CORPUS CHRISTI HOUSING AUTHORITY & AFFILIATES

RFP #19013 - Training Room Renovations - Addendum #1

Date: June 21, 2019

3740 PORT - CFP BUILDING

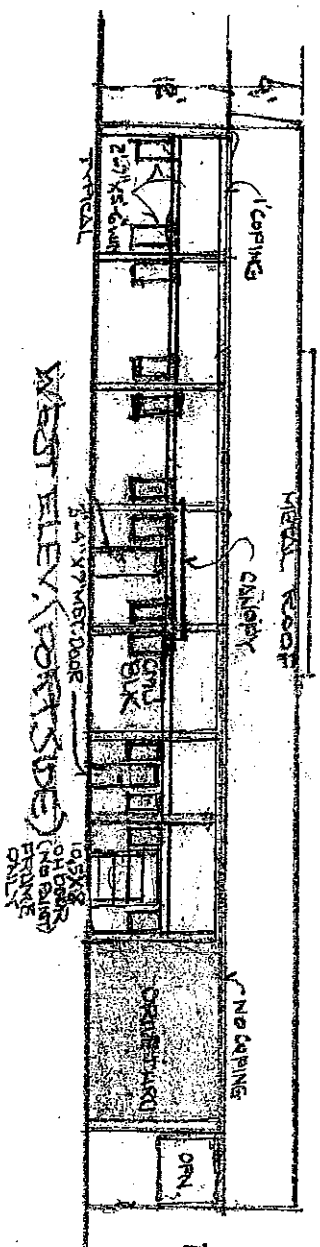
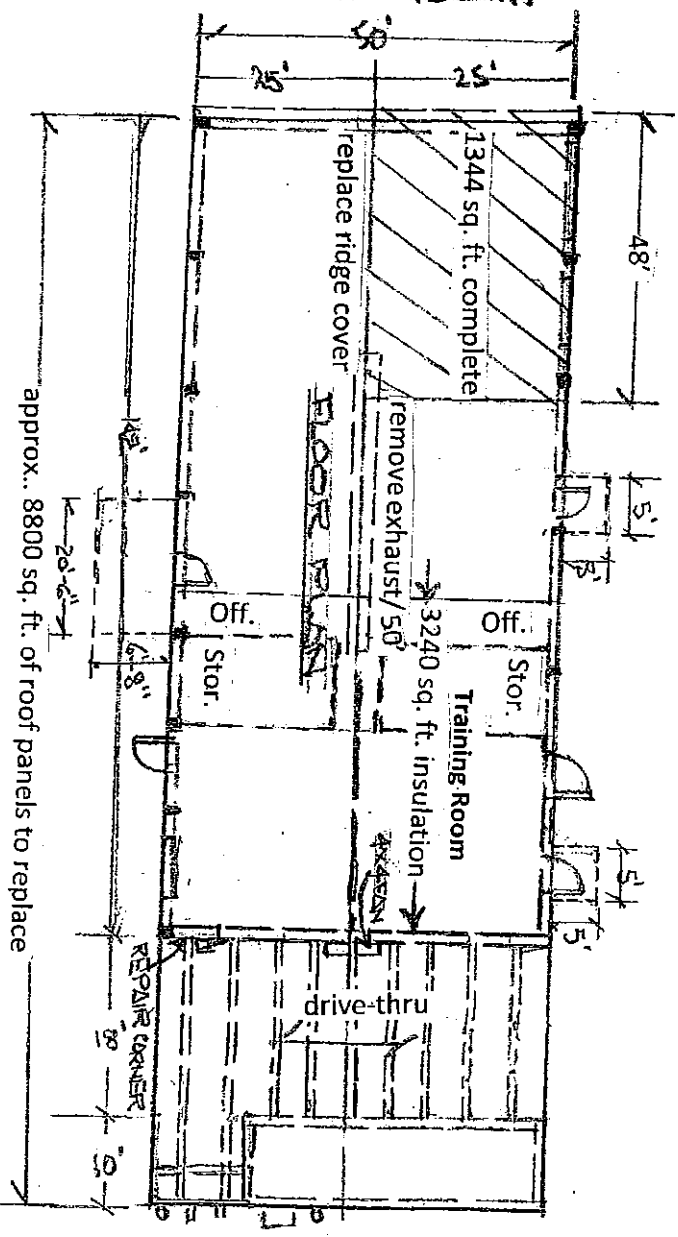
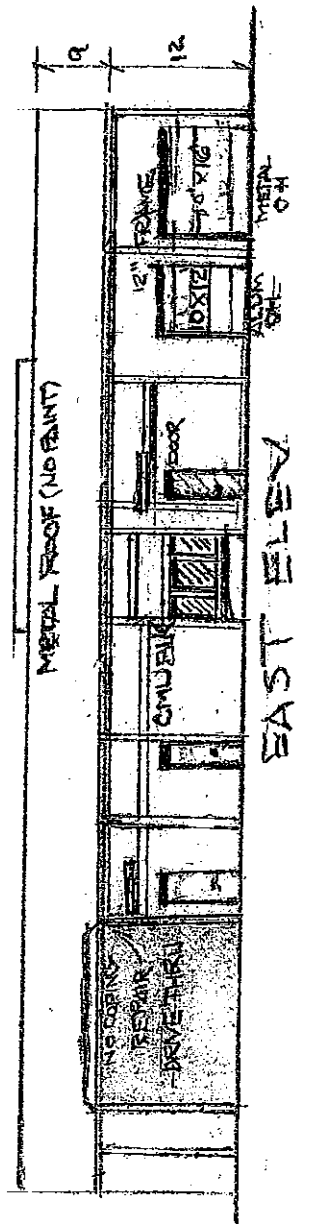
1. Question: Although the square footage is given for the area of roofing to be replaced, we will need to know the exact area limits of roof that is involved. Can you please indicate on the drawings the extent of the roof replacement?

approx. 8800 sq. ft. of roof panels to replace

Answer: Please see attached drawing.
